Eau Claire Residential High Rise
727 1st Ave SW, Calgary, AB

DP2021-3142| UDRP COMMENTS & RESPONSES

Submitted to City of Calgary Urban Design Review Panel
by Graywood Developments + IBI Group
June 2021

SITE PLAN THRESHOLDS / ZONES

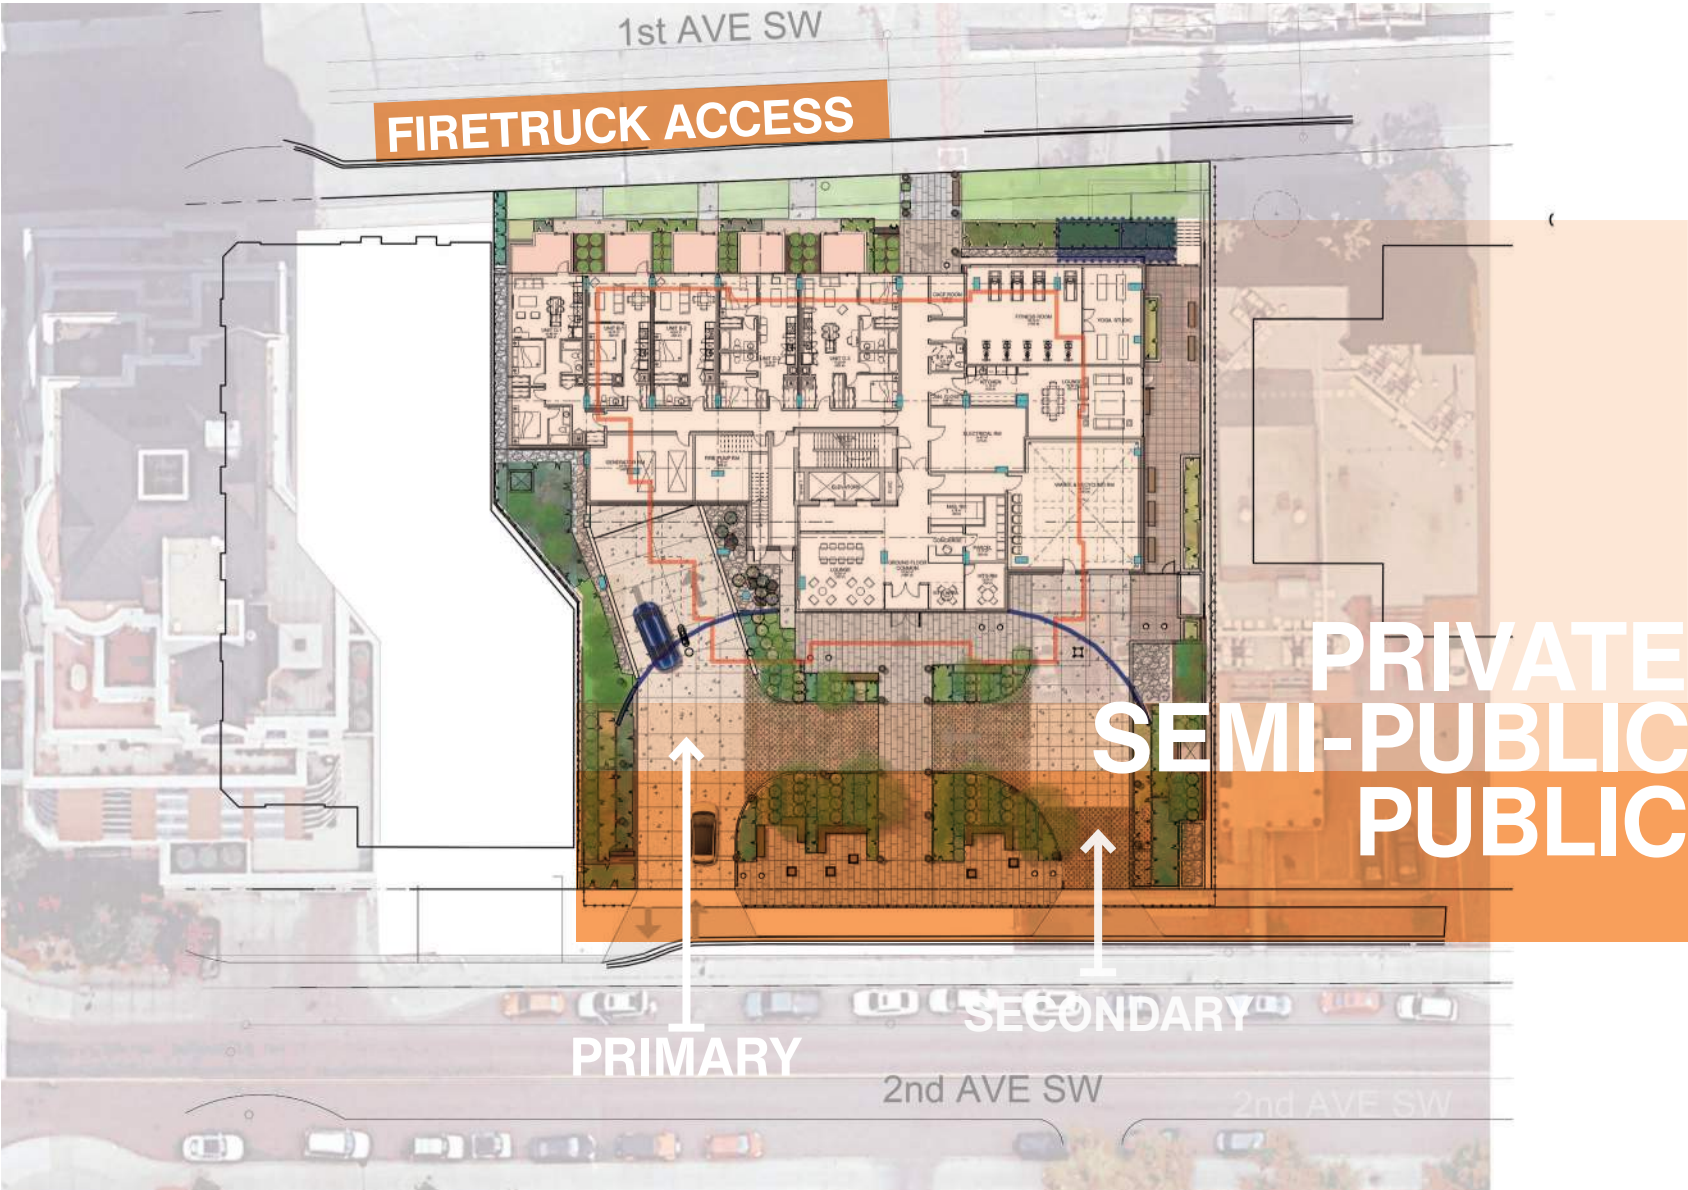
Integration <i>The conjunction of land-use, built form, landscaping and public realm design</i> <ul style="list-style-type: none">• Parking entrances and at-grade parking areas are concealed• Weather protection at entrances and solar exposure for outdoor public areas• Winter city response	
UDRP Commentary	The project is set back significantly from 2nd Ave SW, making this a very 'private' building, not particularly well integrated into the community. Front plaza is suitably landscaped, however vehicular traffic is present in the plaza, including waste & recycling service driving through this area. Option for fire truck access off 1 Ave SW should be reviewed. Townhouse units off 1 Ave SW appear to have a stronger integration however 2-storey units may further improve overall massing of the tower.

The 2nd Avenue design aims to reinforce and provide private indoor, private outdoor and public outdoor spaces delineating the uses and access into the site. We have developed an architecture which emphasizes the public feature through a defining 1 ½ storey curved screen. This screen provides a transition to adjacent buildings 2 storey blank base while subtly concealing the driveway and loading areas. The lobby and entry are designed with large glazing areas and defining round columns which extend two storeys.

The front plaza, landscaping is developed to reduce the impact of the service driveway for the waste and recycling and loading uses. On the other hand more attention is given to the main entrance on the north to increase the impact. We have emphasized the ceremonial aspect of address and entry by designing a front long canopy covering the main entrance which notionally extends out towards the sidewalk.

The Fire access will be off of the 1 Avenue as suggested.

We have reviewed the market parameters relating to providing 2 storey townhouse units at grade. Our client and the market have found that these units, due to size become unaffordable and do not sell. The design of this elevation combines the 1st and 2nd floors in one plane with projecting balconies thus giving a sense of 2 storey units.

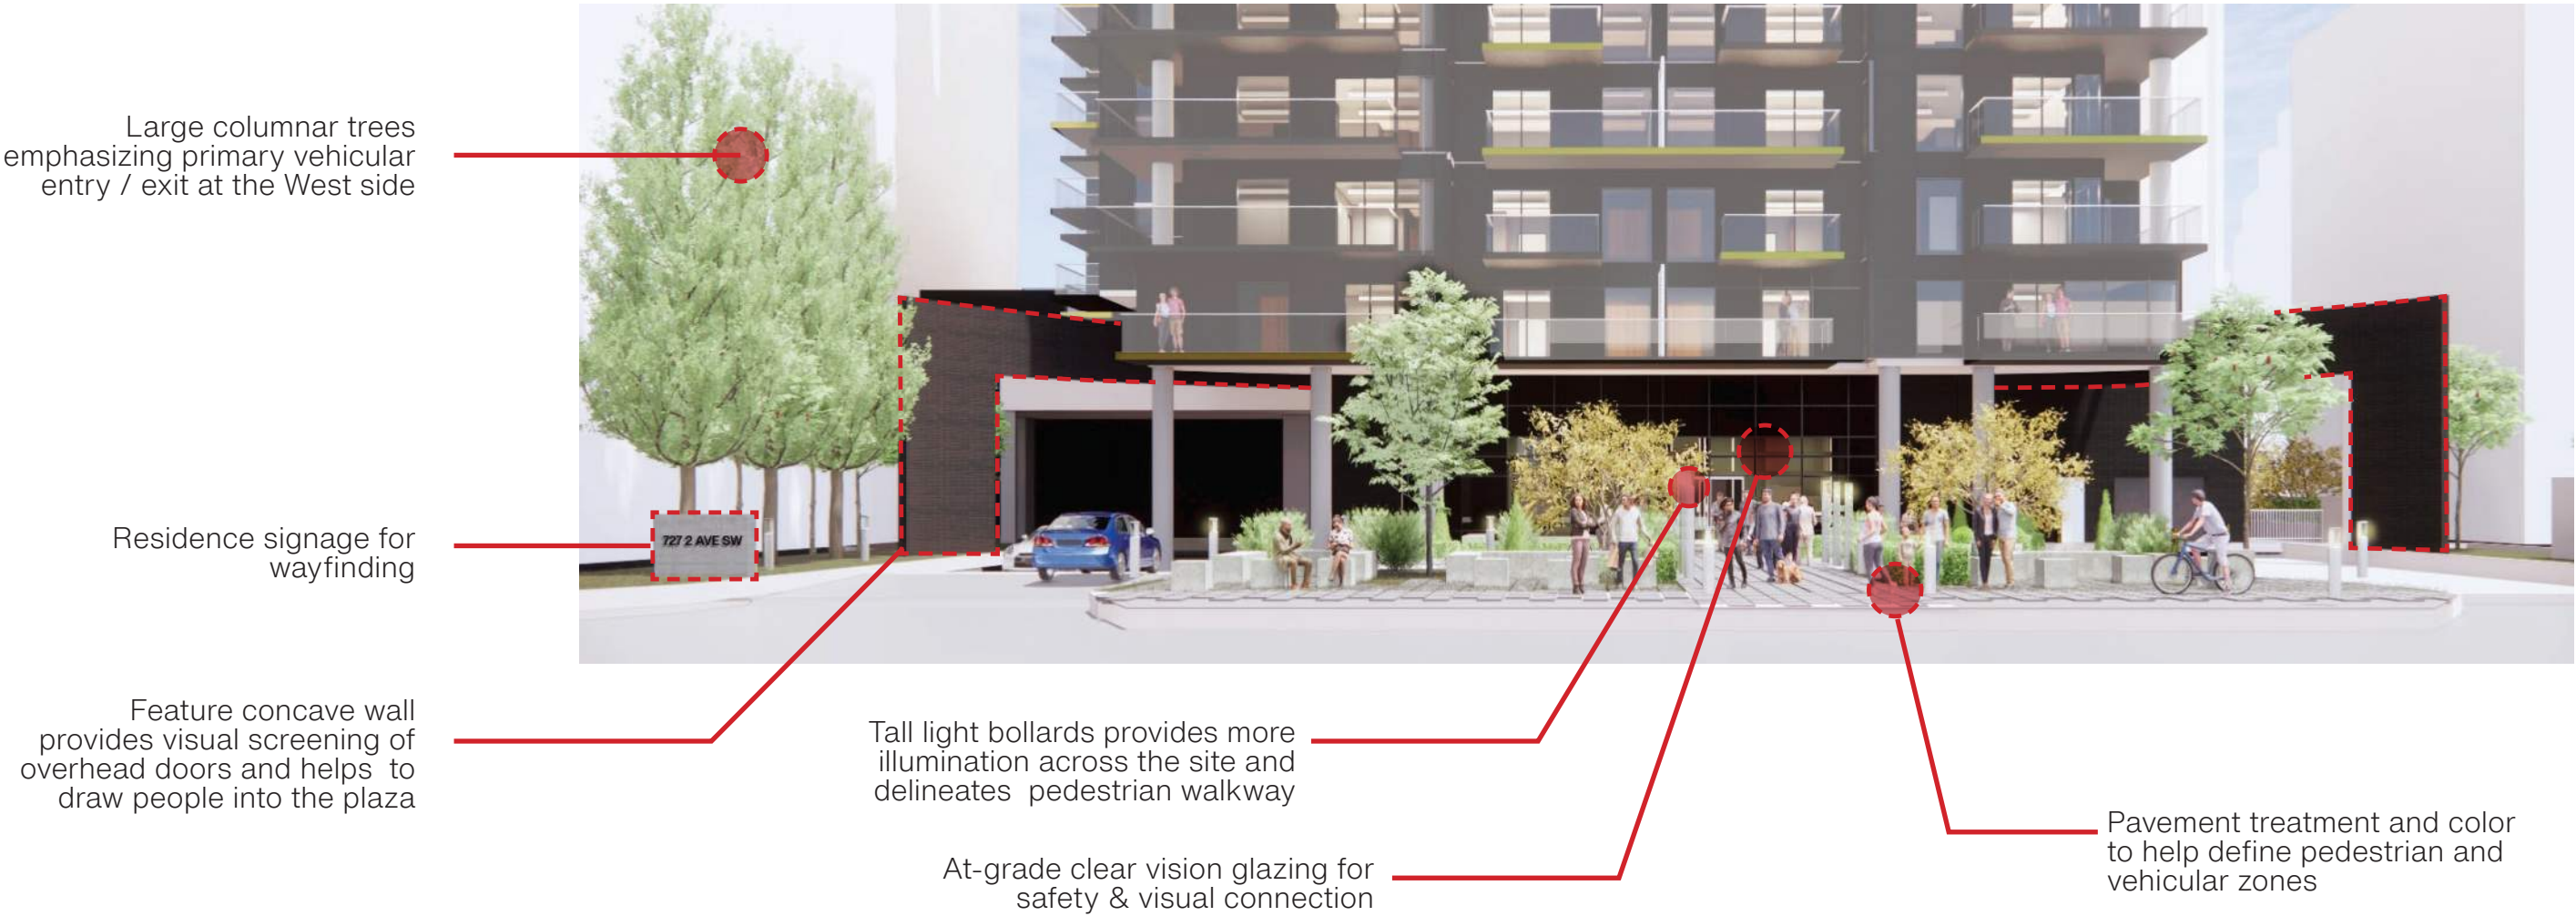
Accessibility <i>Ensure clear and simple access for all types of users</i> <ul style="list-style-type: none">• Barrier free design• Entry definition, legibility, and natural wayfinding	
UDRP Commentary	Project proposes an acceptable degree of accessibility. On-site traffic circulation could be designed better in terms of natural way-finding aspects (lighting, drive surfaces, etc.) to reduce future signage requirements.

Shared pedestrian and vehicular spaces in the plaza are differentiated by paving material, low level light bollards during night and winter times to provide adequate natural wayfinding.

The plaza, and both main entrances in the north and south of the building are all designed according to the barrier free accessible design. The sense of entry approach is reinforced through the use of the large canopy and the plaza in the front. Easy and clear access for all types of users are ensured through use of color, material, landscaping and lighting.

VISUAL CONNECTION FROM AMENITY / GROUND FLOOR UNITS

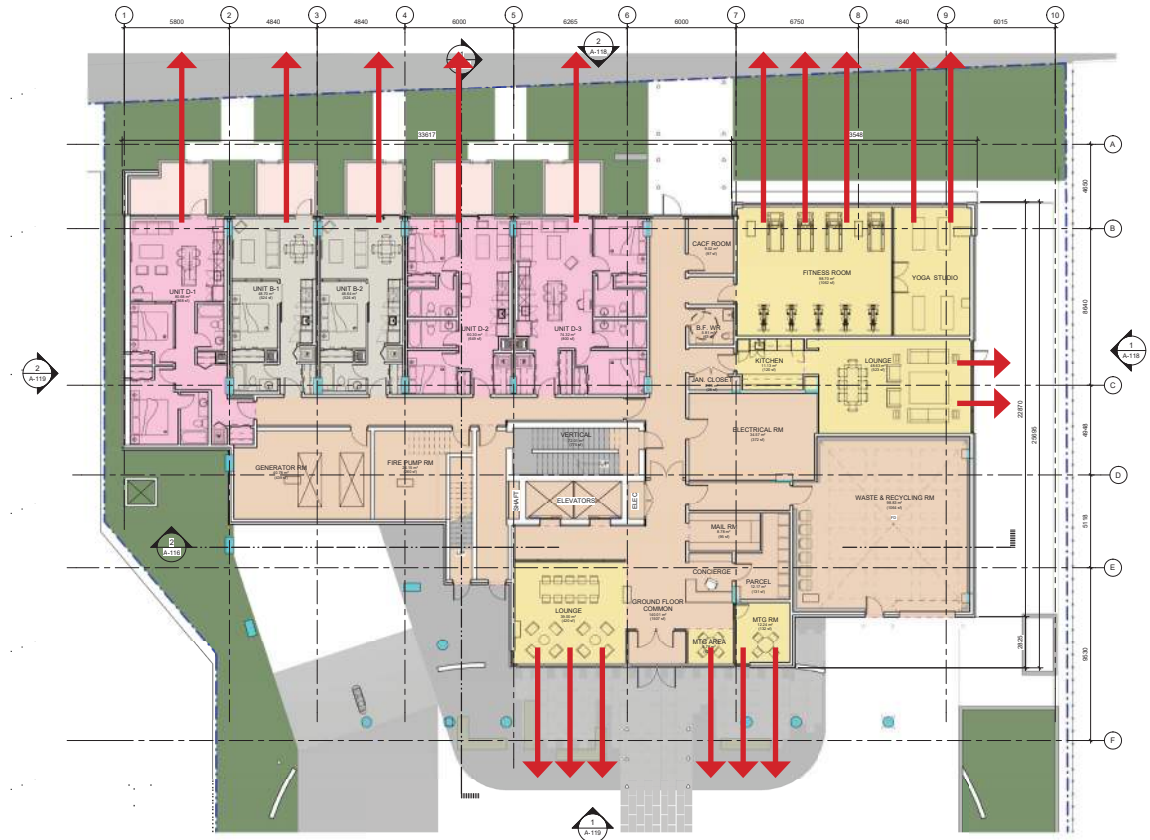
Safety Achieve a sense of comfort and create places that provide security at all times <ul style="list-style-type: none">• Safety and security• Night time design	
UDRP Commentary	Strong use of front canopy and animation of front plaza landscape. Note that the project depends primarily on lighting, fencing, and proposed electronic surveillance to achieve security objectives rather than ‘eyes on the street’ except for the townhouse units along 1 st Ave.

Safety and security of the residents is achieved is not limited to lighting, fencing and surveillance cameras. We have “eyes on the street” provided by the suites and balconies on all levels and the activated social lounge in the main lobby.

The active lobby space with full glass walls allows visual transparency and connection with the exterior. The presence of the concierge in lobby, balconies on both north and south of the building, amenity and the townhouses in the north, patio and the café (Social Spaces) in the front, all provide visual connections and “eye on the street” security for the residence.

Rows of trees in the east and west side of the central plaza create a sense of space and safety. Also raised planting are placed along edges to screen adjacent walls and frame building’s architecture. All areas at grade are utilized to avoid hidden spots and corner for safety and comfort of the residents and public.

9600 Series - Thermally Enhanced Aluminum Window Wall System

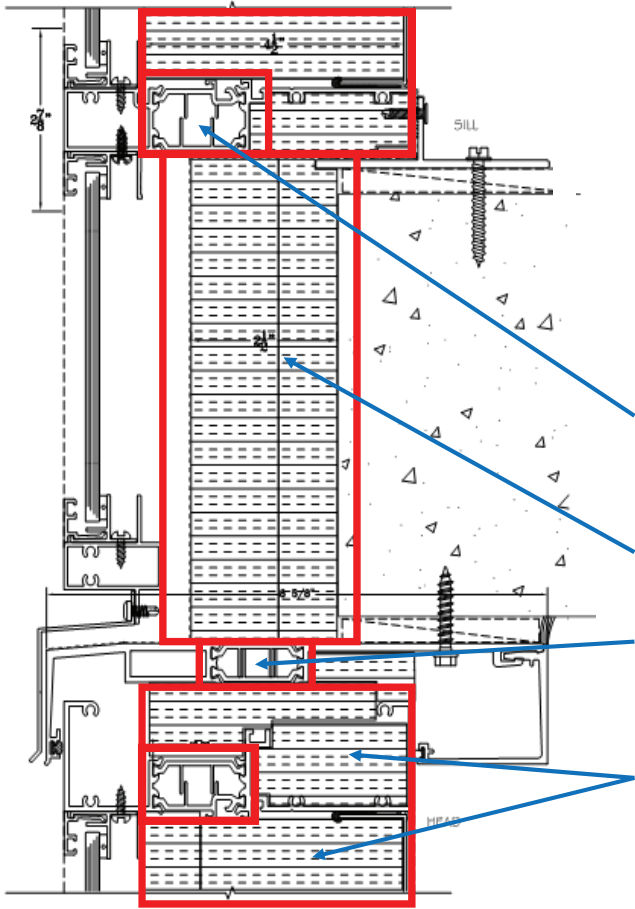
Sustainability <i>Be aware of lifecycle costs; incorporate sustainable practices and materials</i> <ul style="list-style-type: none">• Site/solar orientation and passive heating/cooling• Material selection and sustainable products	
UDRP Commentary	Use of vision glass to provide views to/from the residential units is supported. Reduction of urban-island heat effects are noted and supported in the front plaza landscape design. Applicant may consider a green roof for the Amenity space. Bike storage & lockers are noted as part of proposed application.
Applicant Response	Noted

As part of the development permit submission, the applicant has engaged an energy modelling consultant early on to ensure compliance with NECB requirements and to avoid any major re-design after approval. Many sustainability best practices have been incorporated into the design, including the following:

- Upgraded window wall system with improved R-values
- Reduced window to wall ratio under 33%
- Decreased balcony lengths to reduce thermal bridging in concrete slabs

- Wider (41mm) multi-chamber, dual-strut, polyamide thermal break in all 6"-deep window profiles
- 2 ½" of continuous mineral wool at face of slab edge
- Head Deflection Channel & Seismic Compensation Jamb Channels thermally broken with similar multi-chamber, dual-strut, polyamide
- Insulation in frame cavities with 4 ½" of R-19 mineral wool in the spandrel backpan as well
